EPSC PLAN NARRATIVE

THIS PROJECT INVOLVES THE REPLACEMENT OF BRIDGE #52, RELATED CHANNEL WORK AND INCIDENTALS. BRIDGE #52 CONSISTS OF 2 EACH EXISTING 72" CORRUGATED STEEL CULVERTS, WHICH WILL BE REPLACED WITH A 12' SPAN PRECAST CONCRETE BOX CULVERT TO CONVEY AN UNNAMED TRIBUTARY BENEATH VT ROUTE 30. BRIDGE #52 IS LOCATED IN THE TOWN OF WINHALL ON VT ROUTE 30, 0.05 MILES SOUTH OF THE JUNCTION WITH VERMONT ROUTE 11.

From: Jacqueline Dagesse [<mailto:jdagesse@eivtech.com>]
Sent: Wednesday, April 29, 2015 7:16 PM
To: Lemaire, Ron
Cc: Farley, William; Mackintosh, Mark
Subject: Winhall STP CULV(31) EPSC Plan Review

RE: WINHALL STP (CULV (31) CONTRACTOR EROSION PREVENTION AND SEDIMENT CONTROL PLAN

BRIDGE 52 EROSION CONTROL PLAN 1
SCALE 1" = 20'-0"

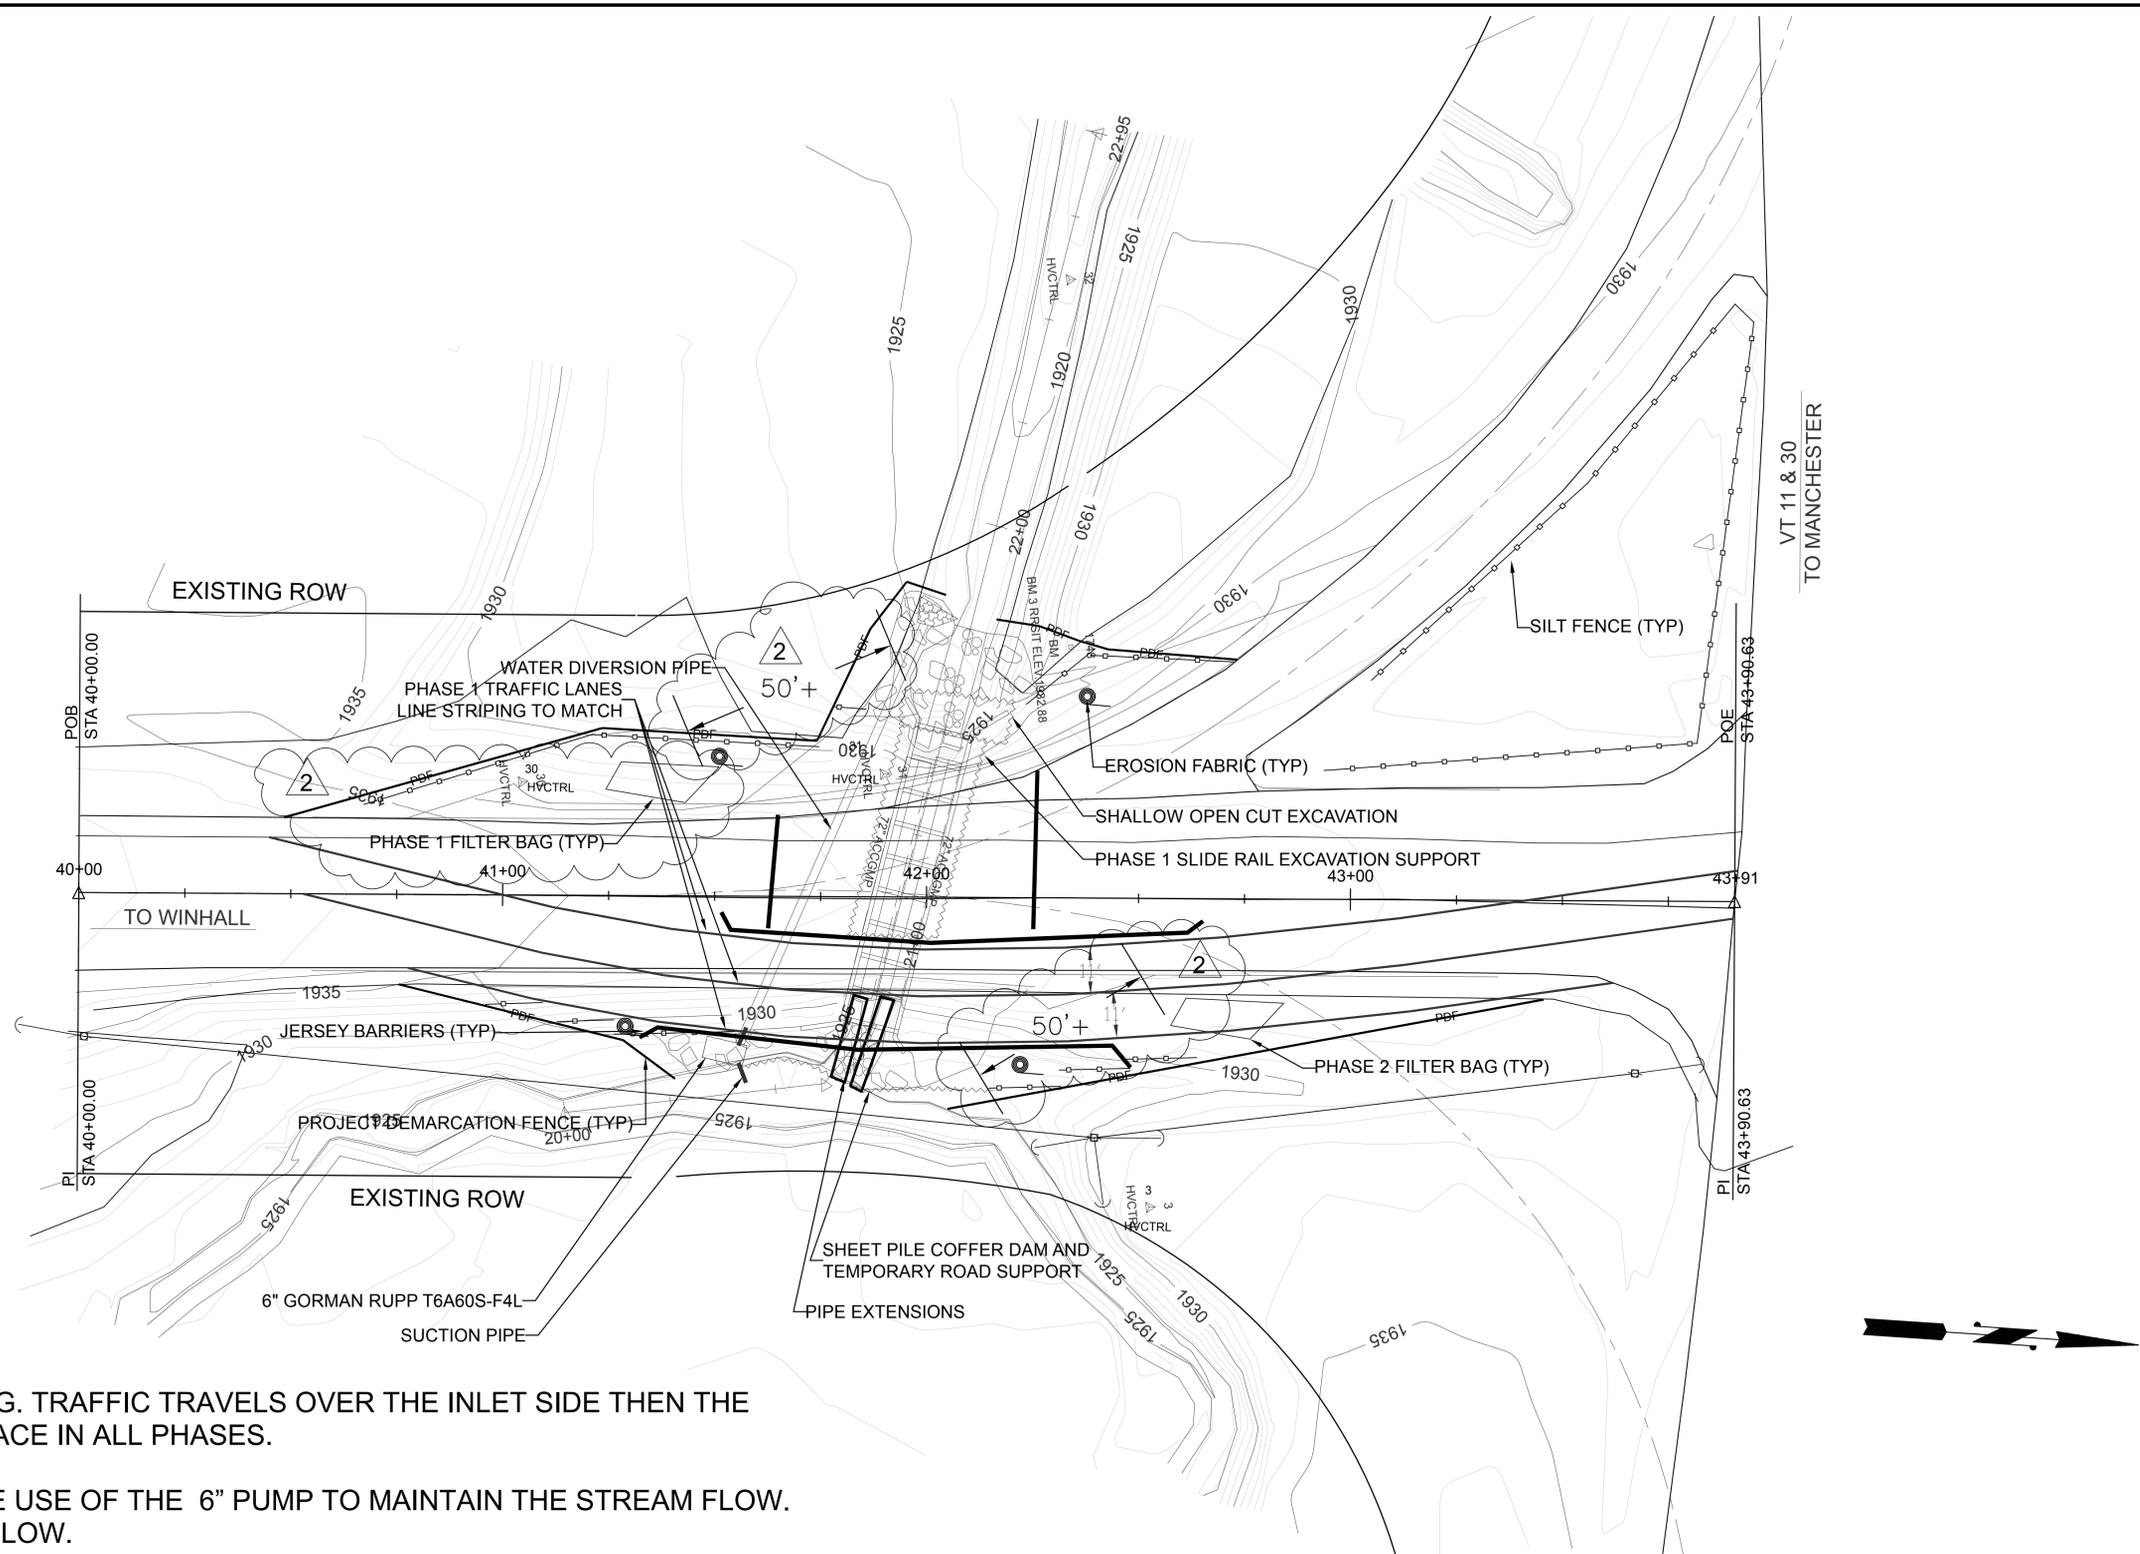
- The plansheets reference 'Phase 1' and 'Phase 2'. What are these phases? There is no description of these phases within the EPSCP narrative. We need additional detail on what they plan to do.
- On sheet 6 of 7 they reference a 6" pump. What is this used for and where is it pumping to? What are the calculations for this sizing?
- Can they confirm if the Phase 1 filter bag is 50' away from the river?

Pease reference these on the EPSC plan.
Show approx. location of silt bag.

SEE TRAFFIC CONTROL PLANS FOR PHASING. TRAFFIC TRAVELS OVER THE INLET SIDE THEN THE OUTLET SIDE. ALL EPSC ITEM REMAIN IN PLACE IN ALL PHASES.

SEE THE STREAM DIVERSION PLAN FOR THE USE OF THE 6" PUMP TO MAINTAIN THE STREAM FLOW. THE 6" PUMP WILL HANDLE THE 25cfs OHW FLOW. THE PIPE LAID ACROSS THE ROAD CARRIES THE STREAM FROM THE PUMP TO THE OTHER SIDE OF THE ROAD. BY BUILDING AN ADAQUATE POND TO DRAW FROM THE PUMP WILL DRAW CLEAN WATER AND DISCHARGE CLEAN WATER. THE CLEAN WATER WILL DISCHARGE ONTO STONE SO THERE WILL BE NO SCOUR. AT THE INLET OF THE EXISTING CULVERTS THE SHEET PILING WILL BE LEFT DOWN TO ALLOW A RELIEF FOR THE STREAM SHOULD IT OVERCOME THE PUMP. THE STREAM WILL FLOW OVER THE LOWERED COFFER DAM INTO THE EXISTING CULVERT TO THE NEW CULVERT AND BACK TO THE STREAM.

THE FILTER BAGS WILL BE PLACED 50' MINIMUM FROM THE STREAM. THY WILL ONLY BE USED FOR LOCALIZED PUMPING FROM THE EXCAVATION WITH 2" AND 3" PUMPS.
